SUBJECT: COMANCHE PEAK NUCLEAR POWER PLANT, UNITS 3 AND 4
DOCKET NUMBERS 52-034 AND 52-035
EVACUATION TIME ESTIMATE REPORT, REVISION 3

SUBJECT: COMANCHE PEAK NUCLEAR POWER PLANT, UNITS 3 AND 4
DOCKET NUMBERS 52-034 AND 52-035
COL APPLICATION PART 2 UPDATE TRACKING REPORT REVISION 2

**Comanche Peak Nuclear Power Plant, Units 3 & 4
COL Application**

**Table 2.5.2-237 (Sheet 2 of 2)
1E-5 and FIRS Amplitudes for FIRS Elevations, Horizontal and Vertical**

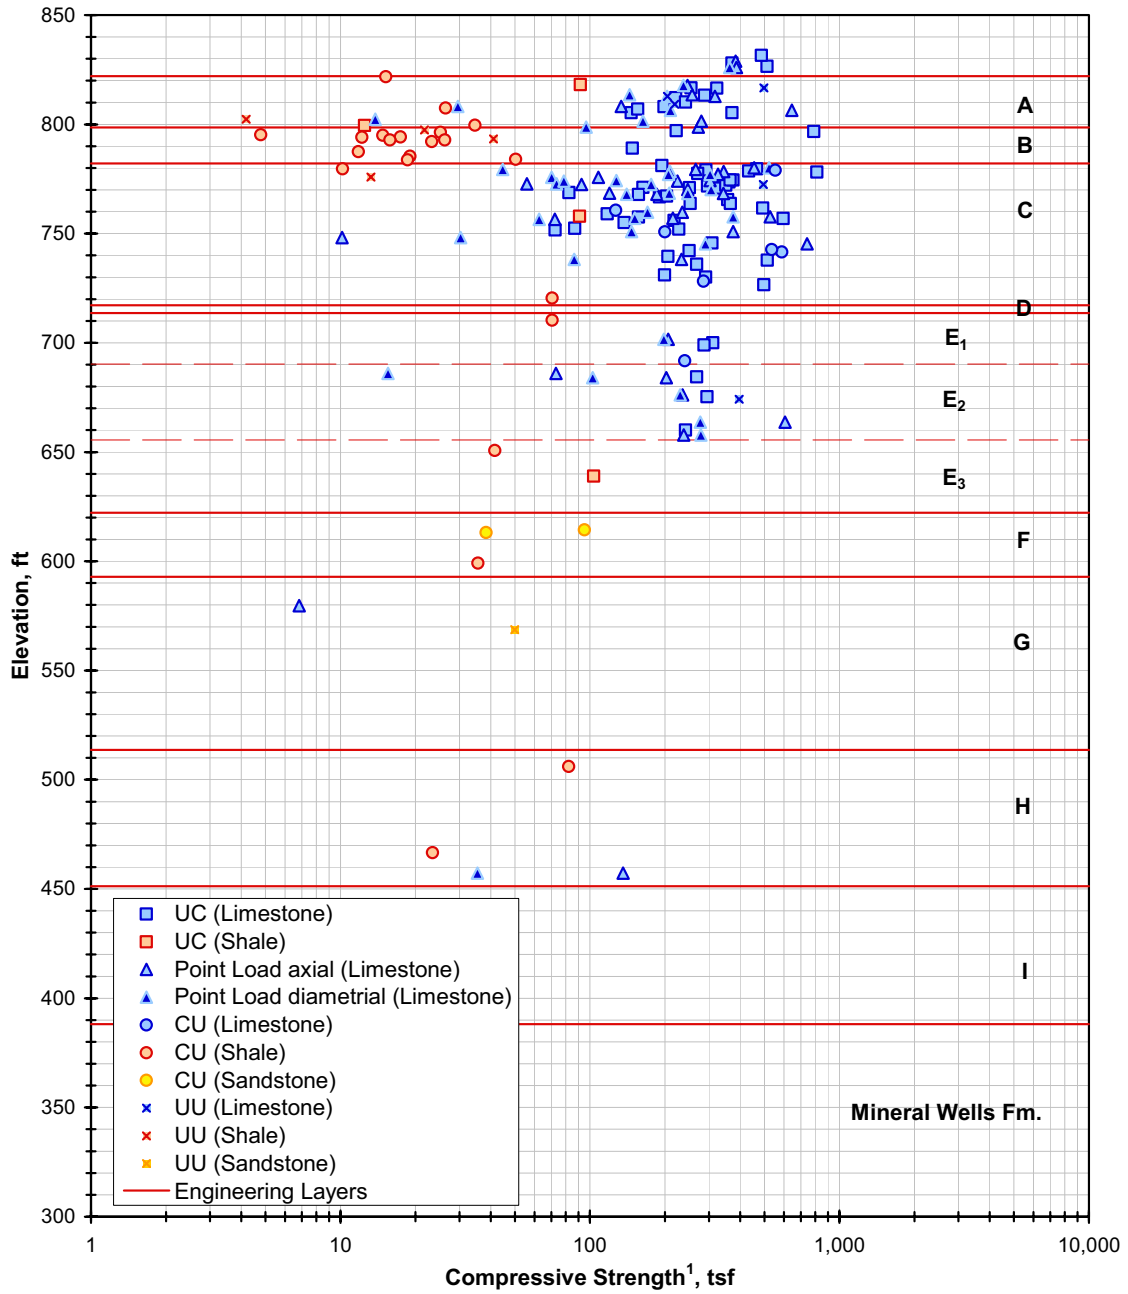
RCOL2_02.0
5.02-16 S01

Figure 2.5.5-205 Post-Construction Cross Section D-D'

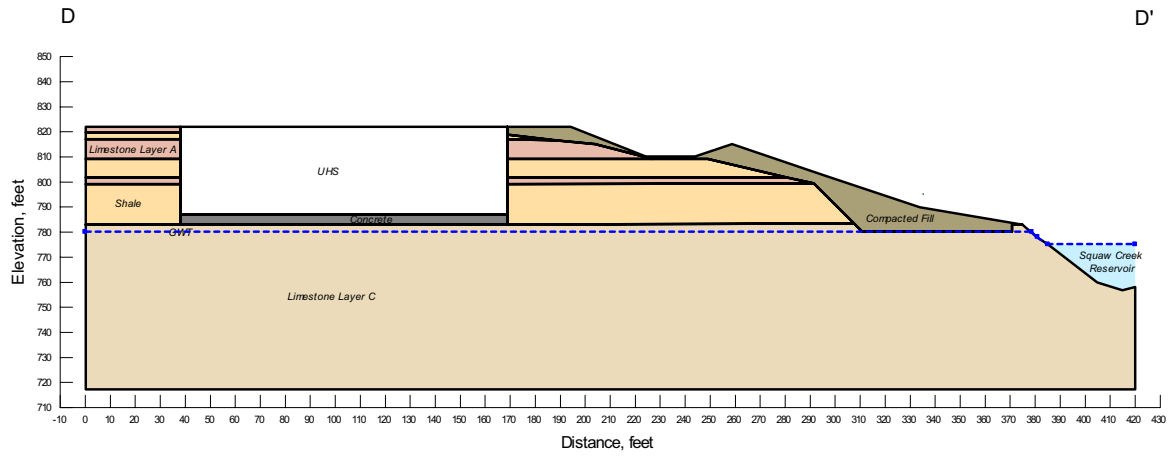
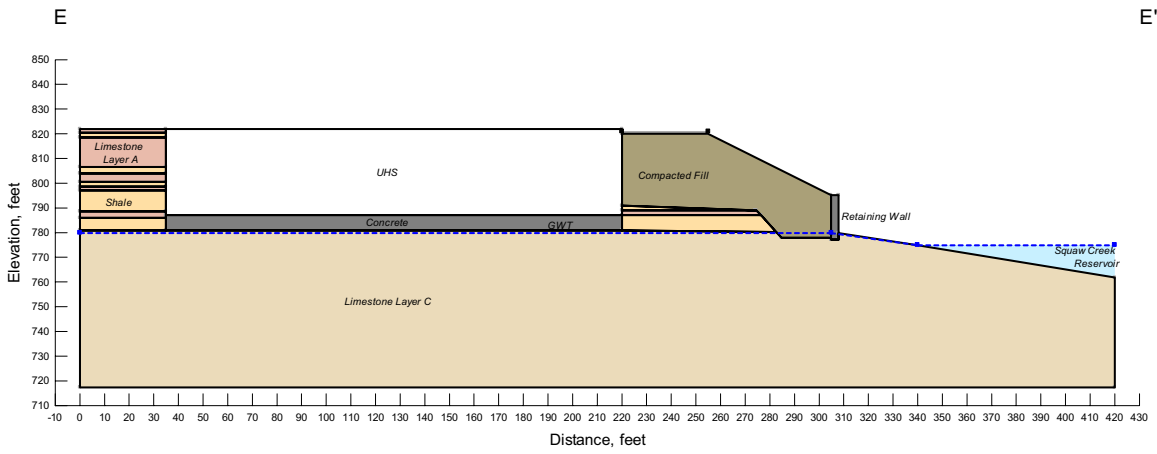
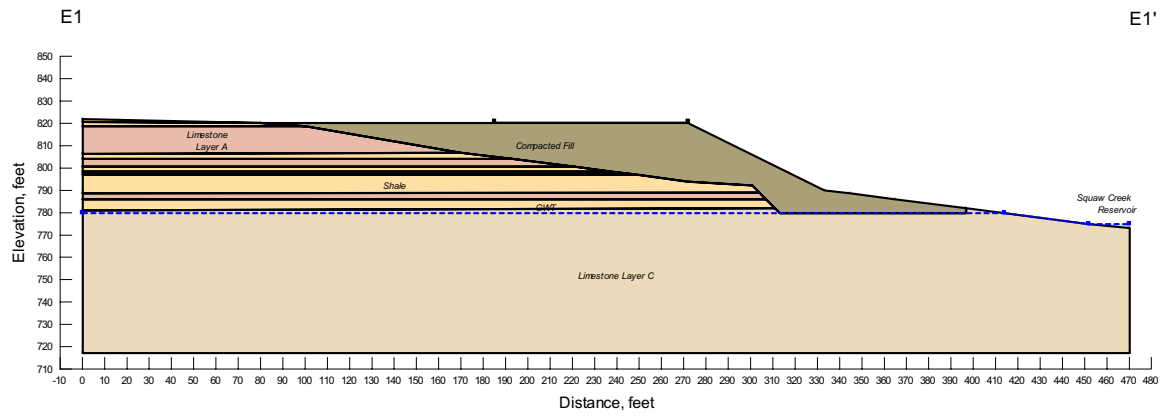
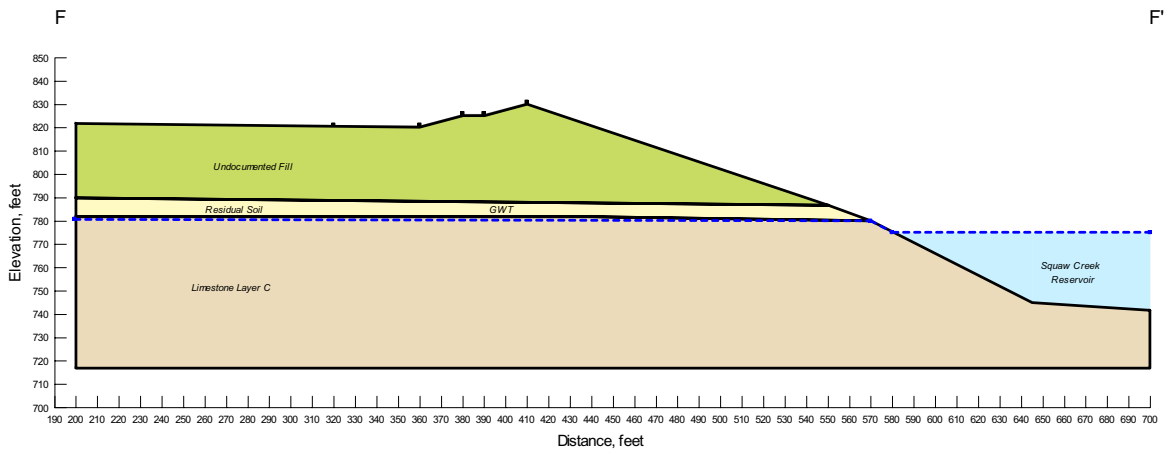
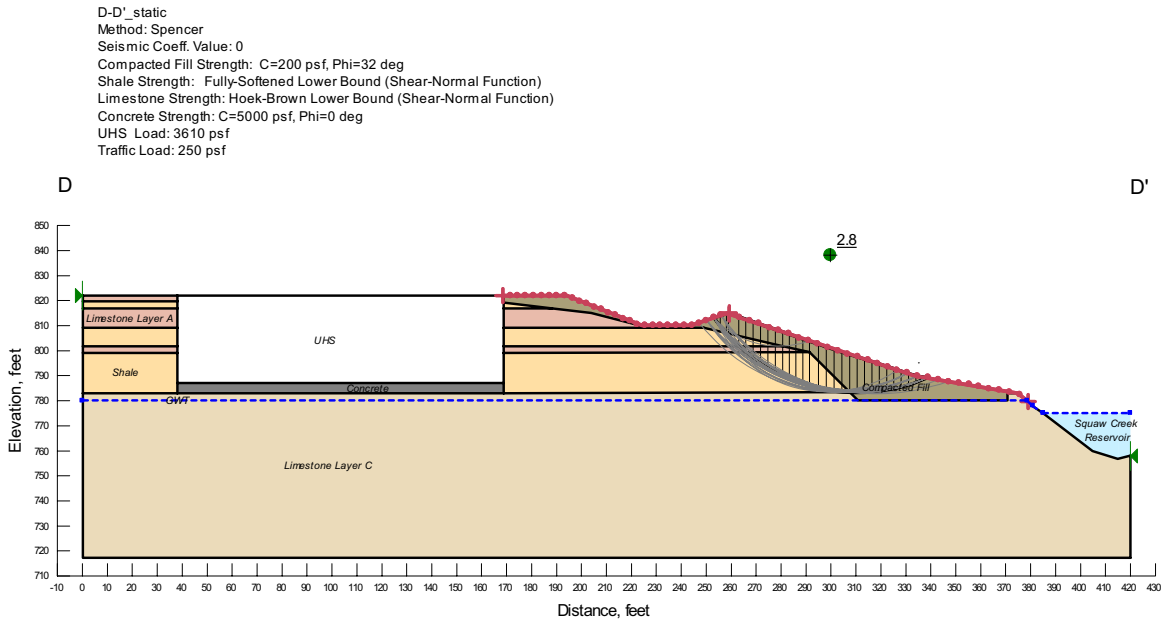
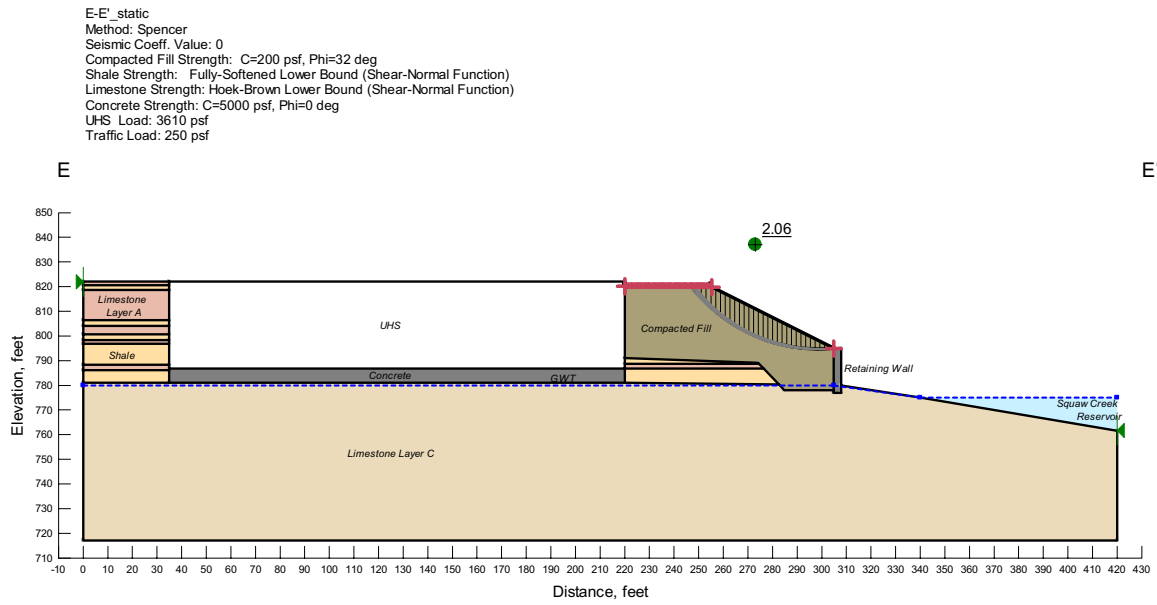
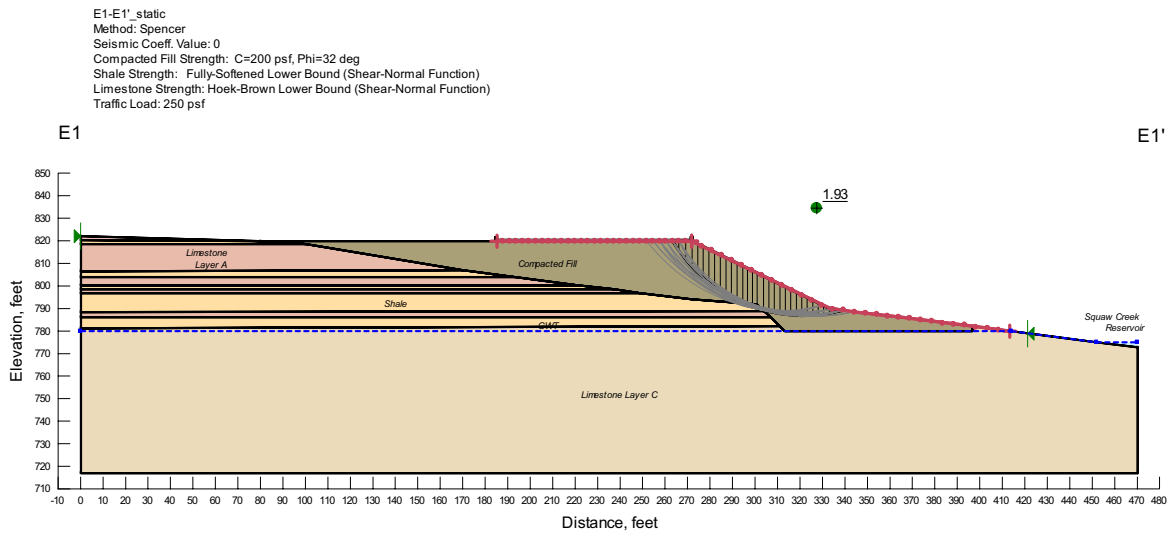
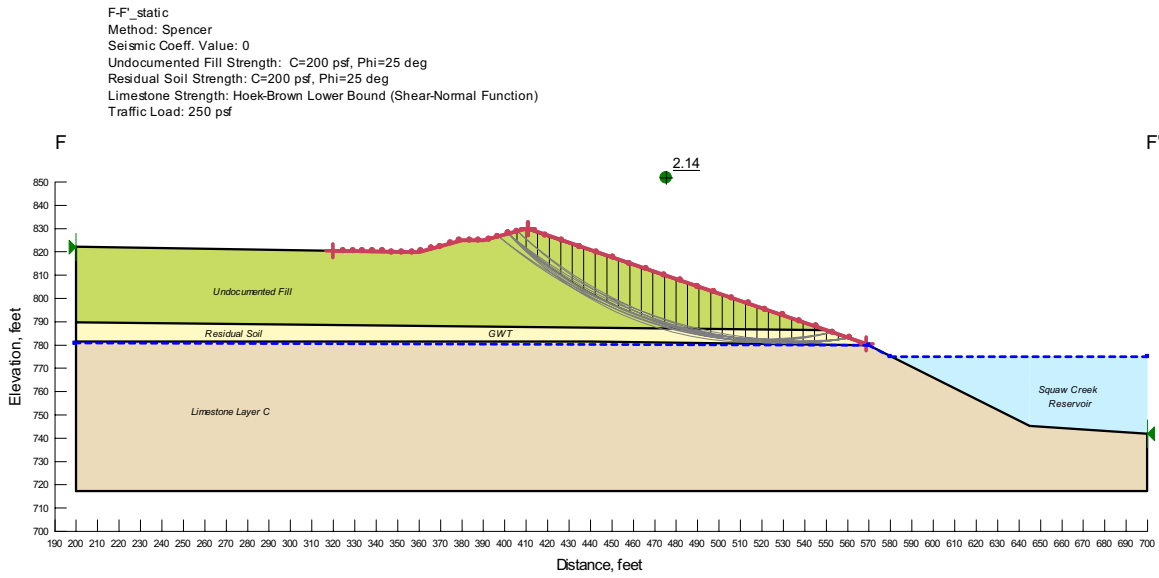
Change ID No.	Section	FSAR Rev. 1 Page*	Reason for change	Change Summary	Rev. of FSA R T/R
CTS-00921	Figure 2.5.5-205 through 2.5.5-212	-	Revised to clarify geologic layers	The colors related to soil on the figures are revised, to be consistent with the revision to figures in provided for RCOL2_02.05.05-1	2

Figure 9.2.4-1R Potable and Sanitary Water System Flow Diagram

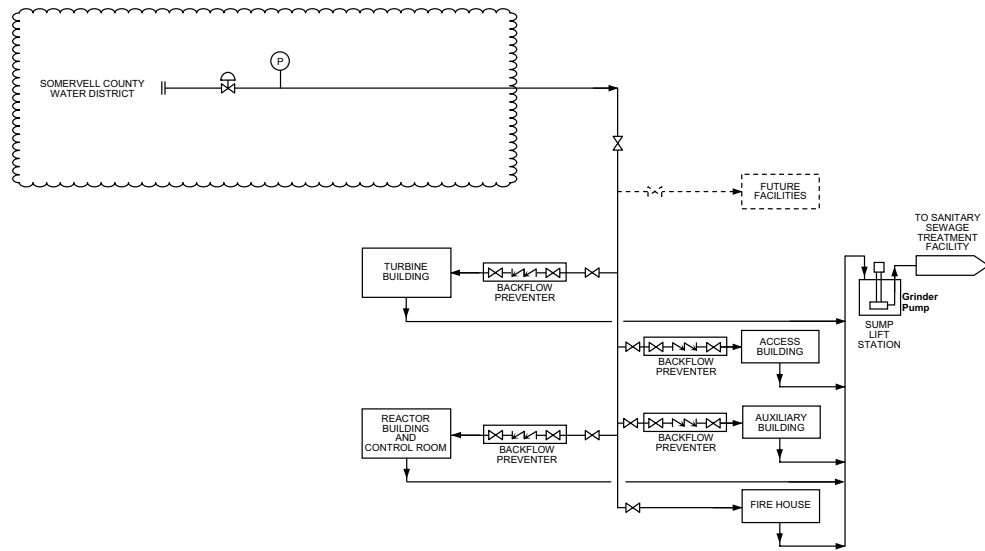
RAI GEN-09	Figure 9.2.4-2R (Sheet 2 of 2)	9.2-29	Response to RAI GEN-09 Luminant Letter No. TXNB-10013 Date 2/24/2010	Added new figure to FSAR Ch 9 to supplement Figure 9.2.4-1R, this figure was not added correctly and the name will be changed to 9.2.4-201 in the next UTR, in addition Luminant requests that the title be changed to "Sanitary Water System Flow Diagram" and "sheet 2 of	-

Change ID No.	Section	FSAR Rev. 1 Page*	Reason for change	Change Summary	Rev. of FSAR T/R
				2" will be removed	
RAI GEN-09	Figure 9.2.4-1R (Sheet 1 of 2)	9.2-28	Response to RAI GEN-09 Luminant Letter No. TXNB-10013 Date 2/24/2010	Added (sheet 1 of 2) to account for above new figure The title of this figure will be modified in the next UTR to comply with the DCD New title: "Potable and Sanitary Water System Flow Diagram" to reflect the DCD In addition "Sheet 1 of 2" will be removed.	-
CTS-01109	Figure 9.2.4-1R	9.2-28	Errata	Corrected figure title.	2
CTS-01109	Figure 9.2.4-201	9.2-29	Errata	Corrected figure number and title.	2
